Preface

Internal exocad Reference: #423314

exocad product, commercial name: *exoplan 3.1 Rijeka*

Field Safety Notice #423314 related to *exoplan 3.1 Rijeka*

Figure 1: Report from the end user who has reported the issue with the too shallow drilling. The red marked drill/tool sequence steps (no. 3-5,7) depicts the steps with the wrong (drill/tool length) information.

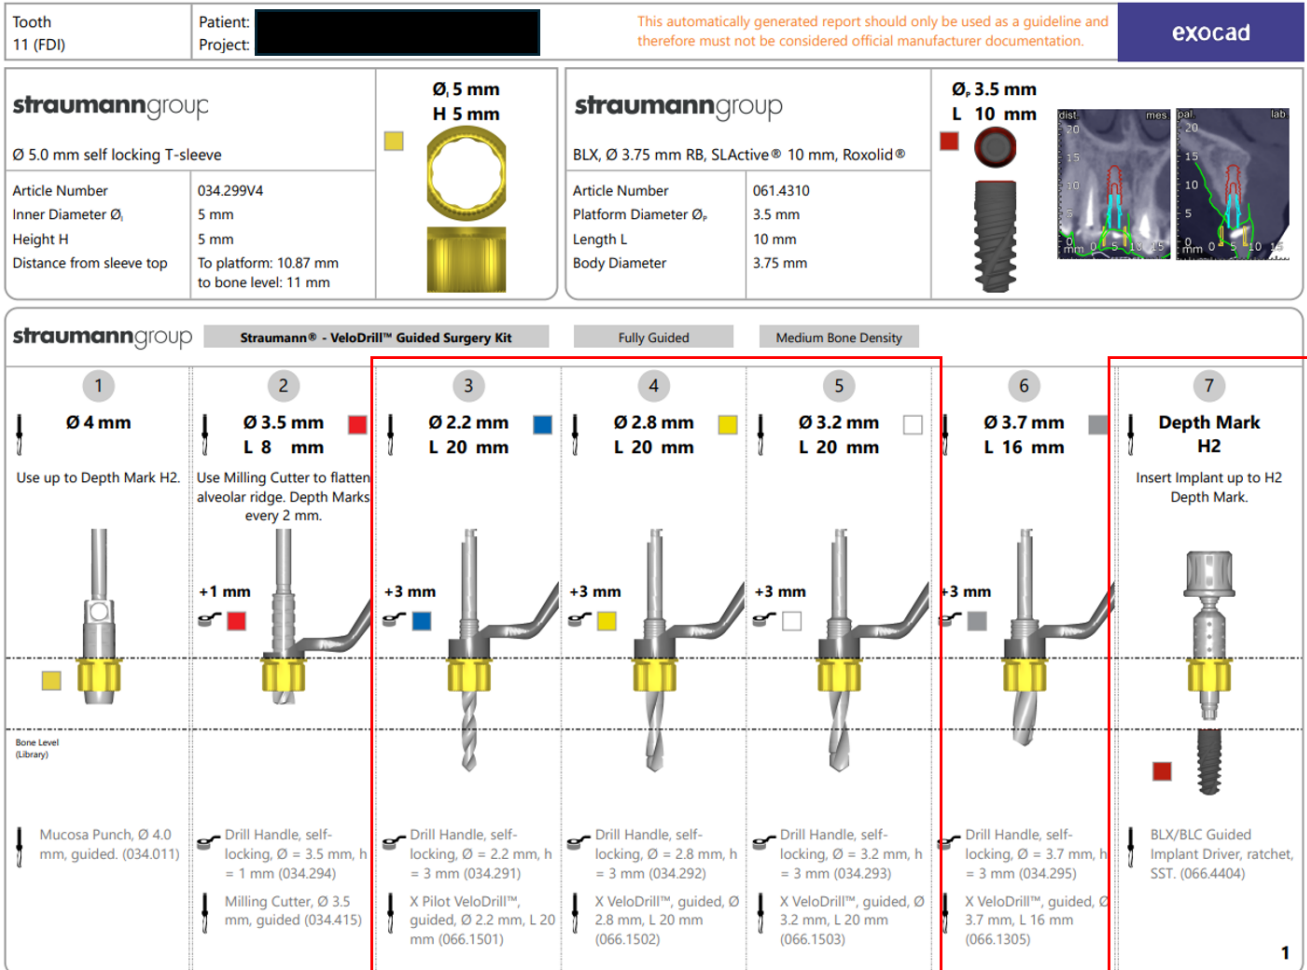
A complaint for *exoplan 3.1 Rijeka* (EB 8657) was reported to exocad by an end user (a dentist based in India) in which the generated surgical report did not contain the complete and correct drill sequence for the selected Straumann® implant, sleeve, and surgical kit system.

The displayed drill/tool sequence in the generated surgical report included drills with insufficient length for the planned implant position (see figure 1 below). The dentist did not notice this discrepancy prior to treatment. As a result, the prepared osteotomy was too shallow to place the implant as planned.

exocad can confirm that this issue only occurred with the legacy version *exoplan 3.1 Rijeka* (EB 8657, 8633 US, 8634 US-offline) and is resolved in *exoplan 3.1 Rijeka* (EB 8752) or later.

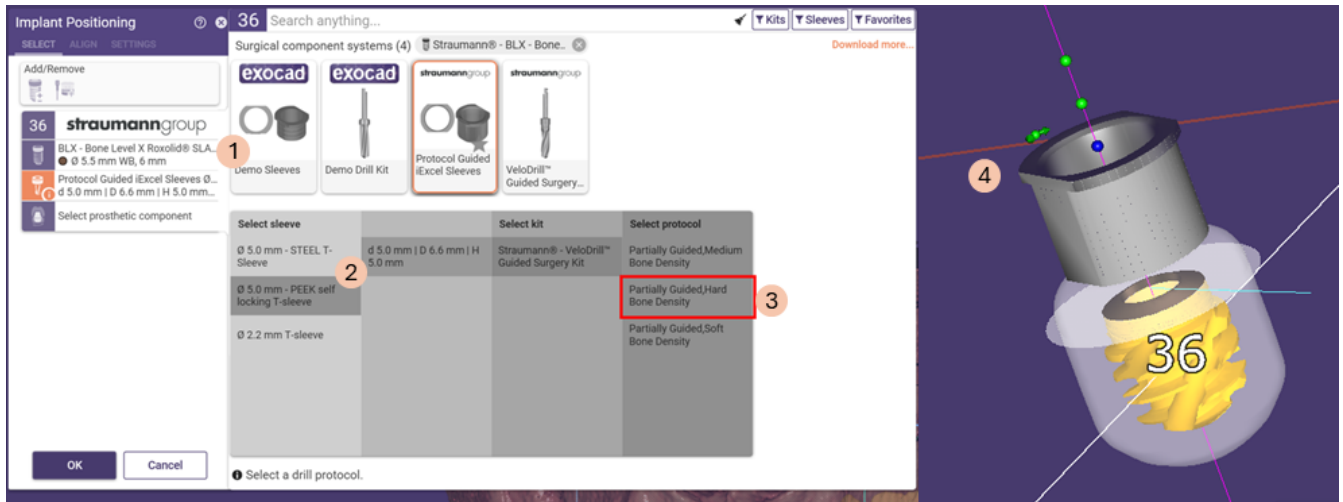
After selecting the implant, the user is prompted to choose a bone density (medium, hard, or soft) and an offset (7, 9 or 11 mm) which describes the distance from the top of the sleeve to the upper platform of the implant. The incorrect drill handle is displayed if the user chooses the following combination:

1. TLX/BLX implants with diameters of 5.5 mm and 6.5 mm and length of 6 mm (see “Affected implants” table below)
2. Ø 5.0 mm –T-sleeves (see “Affected surgical sleeves” table below)
3. Partially guided protocol, hard bone density
4. Sleeve offset 7 mm (closest of three available distances – marked as blue sphere in the figure 2 below)

Figure 3: Example step-by-step drill protocol output of *exoplan*. The drill step number 4 and 5 display the wrong drill handle (h1.0, marked red), step 3 displays the correct drill handle (h3.0).

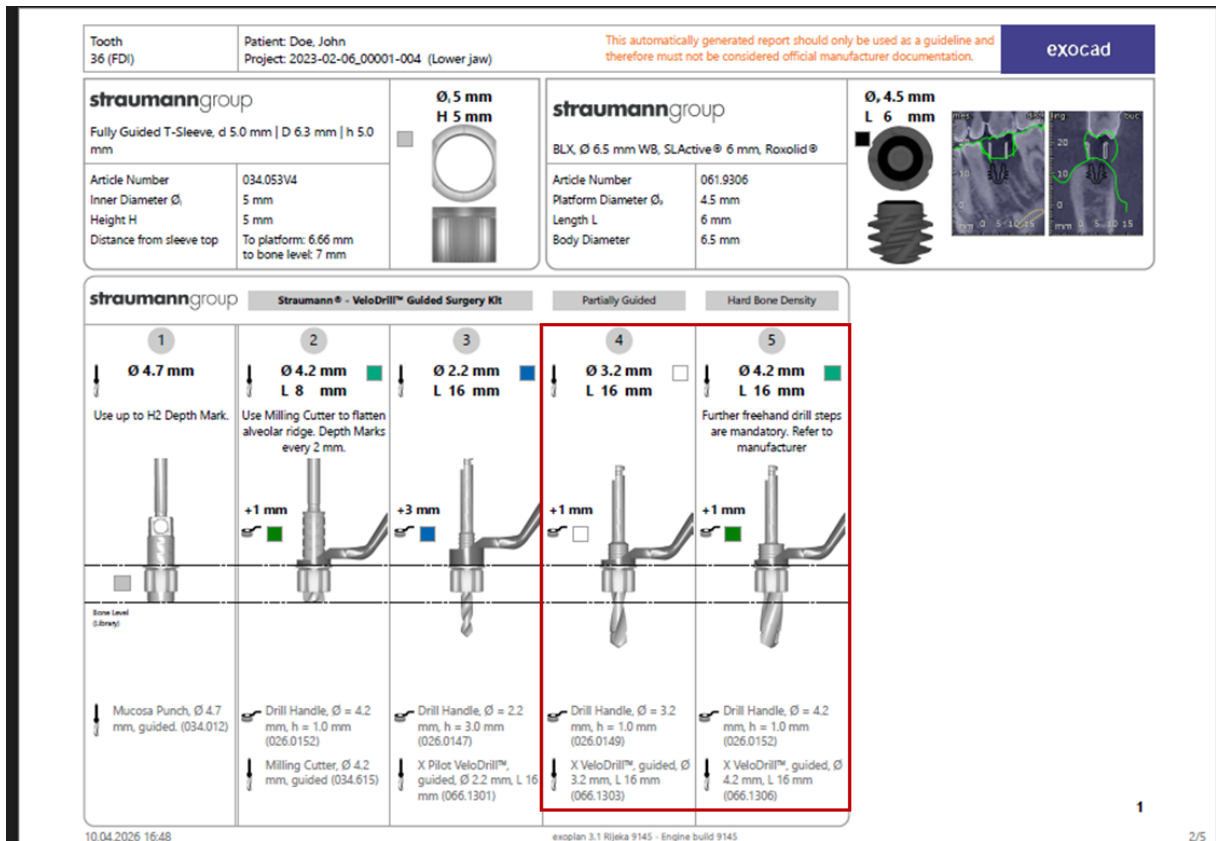
In this case, protocol steps 4 and 5 display the incorrect height of the drill handles for the used drills (marked red in figure 3 below):

When a Straumann® BLX/TLX implant with a diameter of 5.5 or 6.5 mm and a length of 6 mm is planned in combination with a Straumann® BLX/TLX sleeve and the Straumann® VeloDrill-, *exoplan* will show an incorrect handle position for the selected full drill protocol “Partially Guided with Hard Bone Density.” The incorrect information is displayed for the fourth and fifth drill step.

If the incorrectly displayed protocol steps are followed, the user may select the wrong drill handle in steps four and five. This can cause the osteotomy depth to deviate 2 mm from the intended preparation depth.

Figure 4: Combination of parameters available for affected Straumann® implant lines. The red circles indicate options that are not to be used. All green workflow options are safe to use.

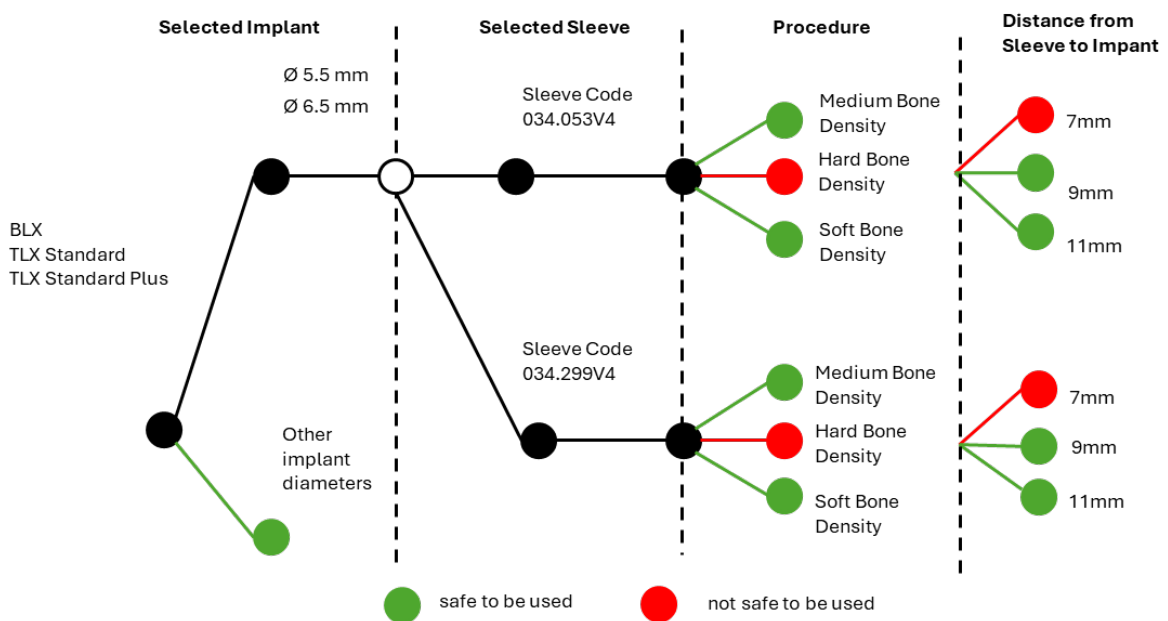
The usage of other Straumann® components is not affected. No other implant sizes, offset distances, surgical sleeves or protocol selections are affected. This chart showcases affected workflows. The red marked workflows are not to be used. Green workflow options are safe to use.
